HOWARD COUNTY HISTORIC PRESERVATION COMMISSION

October Minutes

Thursday, October 1, 2020; 7:00 p.m.

Figure 1 - Location of proposed fence shown with red line.

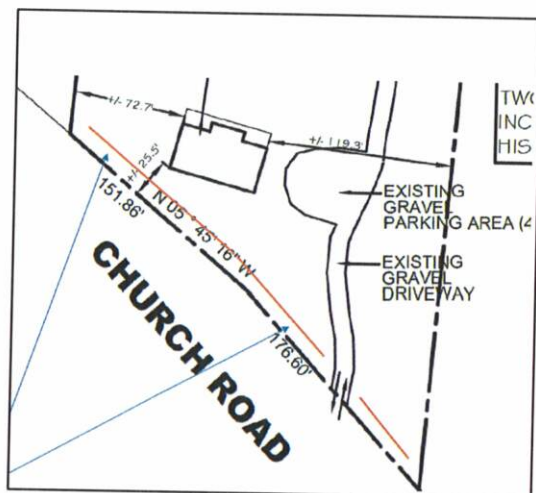
While the Guidelines state that split rail or post and rail fences are more appropriate in less densely developed areas such as upper Church Road, there are no other fences marking property lines in this vicinity, except for the fence lower on Church Road around the Patapsco Female Institute. This would be the first fence in a front yard along upper Church Road.

The style of fencing complies with the Guidelines. The white color will match the siding on the house. Alternatively, a black fence would also match the house (which has black shutters, gutters and downspouts) and may blend into the environment more. Pressure treated posts would reduce the rot, but paint does not adhere to treated wood as well as a good quality hardwood.

The Commission found the application and product to comply with the Guidelines and three of the Commissioners said they preferred the dark brown stain for the fence.

Motion: Mr. Roth moved to approve the application as submitted with the addition that the fence will be stained either dark brown or black, with staff approval of stain color. Mr. Reich seconded. The motion was unanimously approved.

Figure 8 - Historic American Buildings Survey Detail, vignette from 'View of Ellicotts Mills from the Heights above Elizabeth Ellicott's Residence' Lithograph, E. Sachse & Co.,

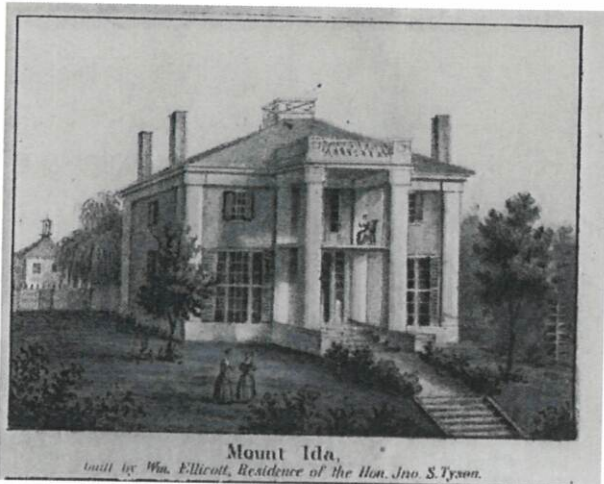
The building has been without railings for much of its life, and the design of the original railings is unknown. Figure 8, below, shows an 1854 lithograph view of the building. While the artist rendering in Figure 8 shows the building without a railing, it most likely had one for safety reasons. Safety is also the reason for the request to add railings now. Chapter 6.F states that "altering a porch can dramatically alter the appearance of a building" and recommends that if a porch must be replaced, "even if simplified in detail, should reflect the visual weight of the original." The original design is unknown so a simplified design, minimal in bulk and visual appearance, such as a white wood picket, would retain the character and avoid altering the appearance of the building.

Although page 4 of the application states wood, the materials proposed to be use is pressure treated wood or a composite wood. Quality hardwood that is primed and painted would be appropriate materials for a porch on a historic building. The proposed flooring is lpe and would not be painted. Typically, a porch floor would be painted tongue and groove wood. However, due to the location of the second-floor porch, the flooring will only be visible to someone standing on the porch, and will not alter the overall appearance of the structure.

Figure 9 – Northwest Elevation - Historic American Buildings Survey Detail from 'A Sketch from Rock Hill' Lithograph of Thomas Campbell, Baltimore, Drawn by R. C. Long, c. 1835 Howard County, MD

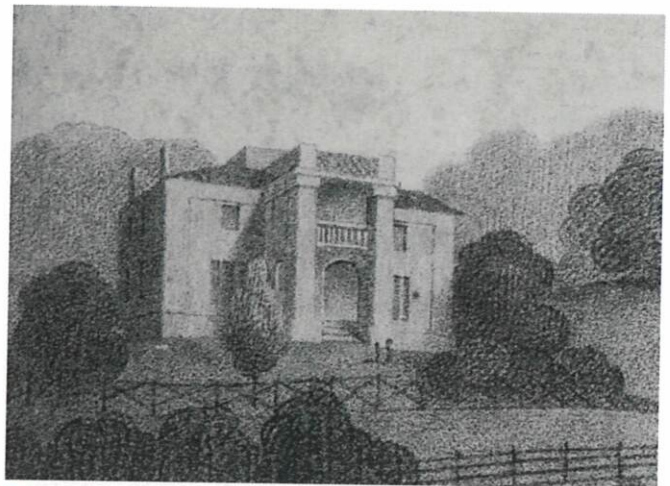
Mr. Reich noted there was no clear historic record of what existed and he could not determine what was most historically appropriate. He said the current rear elevation looks odd with the entry into the basement and referenced Figure 5 of the staff report "Northwest elevation facing Mt. Ida and Courthouse parking lots" stating the basement would typically have had a side entry stair and the main rear elevation entrance would have had stairs leading straight up to the first floor. Mr. Reich noted a preference for this solution acknowledging it was an expensive remedy. Ms. Kepnes suggested painting the first-floor railings white to bring more attention to that entry and paint the basement doors darker to better blend them.

Ms. Zoren noted the column lengths visible in Figure 5 and said that having the porch deck extend out perpendicular forward from the doors would create a horizontal deck line that would visually shorten the columns by about 3 feet. She explained this would give the appearance of a weird intersection with the vertical columns. Ms. Zoren agreed with Mr. Reich's suggestion to build a front set of steps with a side access stair going down to the basement. Ms. Zoren said the Commission would need to see elevations and a section showing the access to the basement when the Applicant comes back for a Certificate of Approval. The Commission will need to understand the two side stairs proposal to the first floor and how that will work with the service stairs if that solution is kept as the plan.

Mr. Reich said the columns were probably shorter originally, given the other elevations on the building. Mr. Reich said the columns would look better if the stone base continued out to the porch level, similar to the base on the elevation overlooking Church Road. Mr. Reich suggested building the porch to come out even with the column on the outside rather than inside. Ms. Zoren referred to the lithograph in Figure 9 and noted the stairs could have started at the columns. Mr. Roth asked how realistic the lithograph really was. Ms. Zoren said it might not be realistic, but it shows the columns hitting the same place they do right now with relationship to the front first floor door. Mr. Roth said the picture does not show the basement door at all.

Figure 24 - Historic outbuildings facing Knoll Glen Drive to be relocated. Currently located on proposed Lot 3.

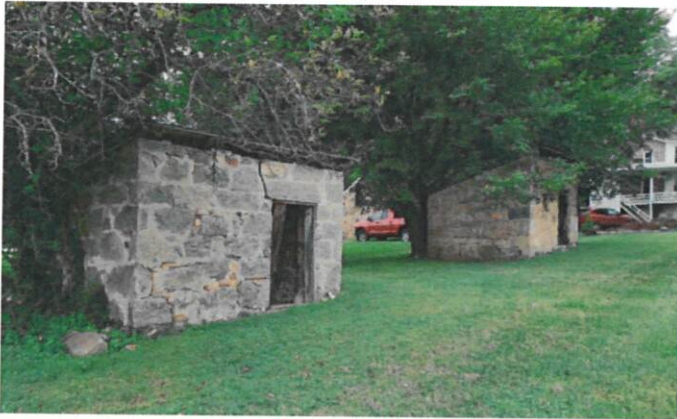
establishment of Lot 3 will also impact the ingress and egress for Lot 1. Should the existing rear driveway for Lot 1 be retained, the existing outbuildings would provide a more appropriate buffer from Lots 4 and 2 than an added vegetated buffer. Due to the condition of the historic outbuildings, they will require extensive repair in the stonework before they can be moved. There is significant deterioration of mortar on all of the buildings, and it is unlikely they can be moved unharmed in their current condition.

Ms. Tennor and the Applicant discussed the preservation of the outbuildings on the property. Currently there is one outbuilding on Lot 1 that will remain in its footprint, and three more outbuildings on Lot 3 to be deconstructed and reconstructed. Ms. Tennor said there appeared to be more than three outbuildings on Lot 3. Mr. Alomer said the four outbuildings with an X through them on the plan were only foundations and did not have any structures on the foundation. Ms. Tennor said they were still substantial foundations. She asked if the outbuilding currently existing on what was to be Lot 1 would be restored at the same time the three other outbuildings were deconstructed, relocated to Lot 1, reconstructed and restored. Ms. Holmes said she was under the impression that the buildings were not going to be deconstructed and reconstructed but relocated in its entirety. Mr. Alomer said that all four outbuildings would be restored, but the three outbuildings moving from Lot 3 to Lot 1 would have to be deconstructed and reconstructed as the foundations for those buildings were in poor condition and would crumble if relocated. Mr. Alomer said the plans for Avoca were still in the concept phase and with schools currently closed, the subdivision and the outbuilding restoration may not take place for another 6-8 years. The extent of the restoration needed on the outbuildings are unknown at this time. Ms. Tennor said the stones will need to be numbered when deconstructing the outbuildings.

Mr. Reich agreed with Mr. Roth to get rid of Lot 3, so that Lot 1 could have the back driveway entrance and the accessory structures do not have to be moved. He suggested improving and increasing the amount of landscaping by planting more evergreens between the historic house and subdivision lots. Mr. Alomer confirmed that increased planting could be done.

Ms. Zoren was surprised with how much she liked the site plan and thought there were a lot of positives and only a few negatives. She said that all the negatives can be solved by adding Lot 3 to Lot 1. In keeping the outbuildings where they currently are located would increase the likelihood of their survival and keeps them in their historic setting. The outbuildings have a historic relationship to the house and to restore in place would be significantly less expensive.
